## Product Change Notification / ASER-28RAPG851

CCB 5128 Initial Notice: Qualification of a new lead frame design and G700 as a new mold compound material for selected MIC277xxx device family available in 5L SOT-23 package assembled at STAR assembly site.

**CCB 5128**  
**Pre and Post Change Summary**  
**PCN #: ASER-28RAPG851**

# Lead Frame Design Comparison

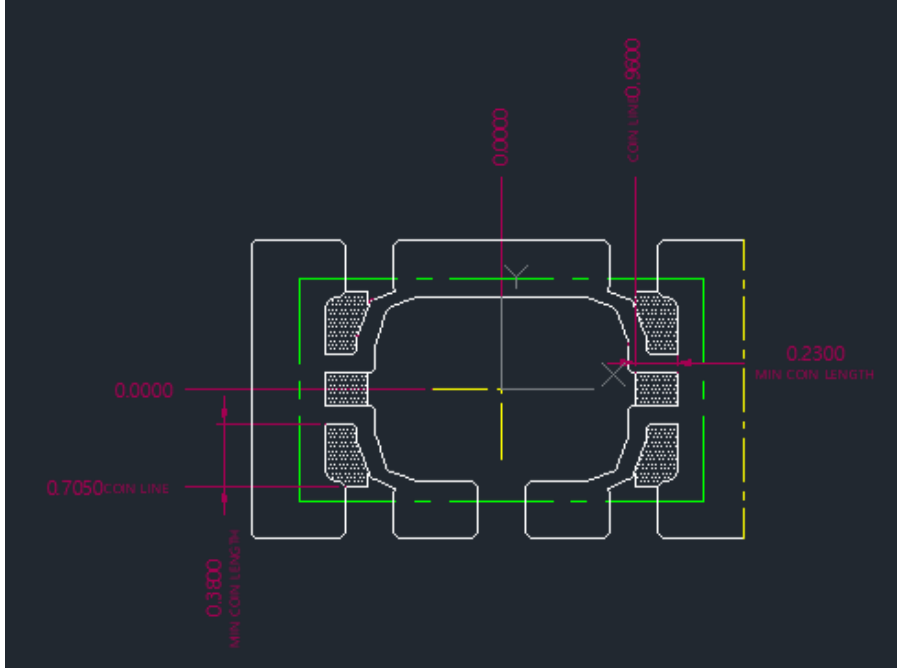
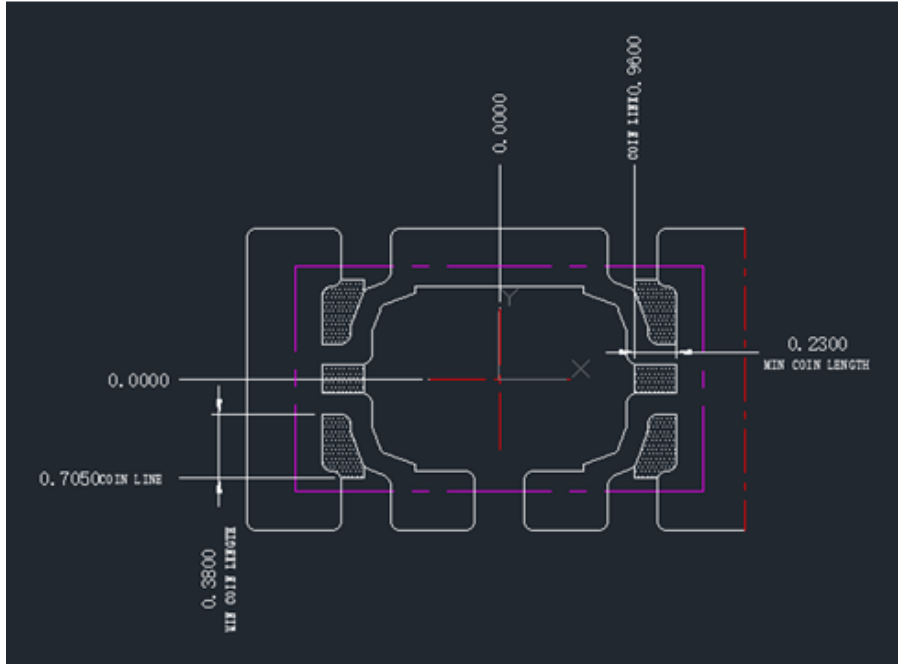
Pre Change		Post Change	
 <p>Diagram of the Pre Change lead frame design. It shows a central die cavity with four leads. Dimensions are indicated in red: 0.0000 (width of lead), 0.7050 COIN LINE (width of coin line), 0.3800 MIN. COIN LENGTH (length of coin line), 0.0000 (width of lead), 0.2300 MIN COIN LENGTH (width of coin line), and COIN LINE 0.9600 (total width of coin line).</p>		 <p>Diagram of the Post Change lead frame design. It shows a central die cavity with four leads. Dimensions are indicated in white and purple: 0.0000 (width of lead), 0.7050 COIN LINE (width of coin line), 0.3800 MIN COIN LENGTH (length of coin line), 0.0000 (width of lead), 0.2300 MIN COIN LENGTH (width of coin line), and COIN LINE 0.9600 (total width of coin line).</p>	
Lead Frame Material	DAP Surface Prep	Lead Frame Material	DAP Surface Prep
C194	NiPdAu with Roughened	C194	NiPdAuAg with Roughened
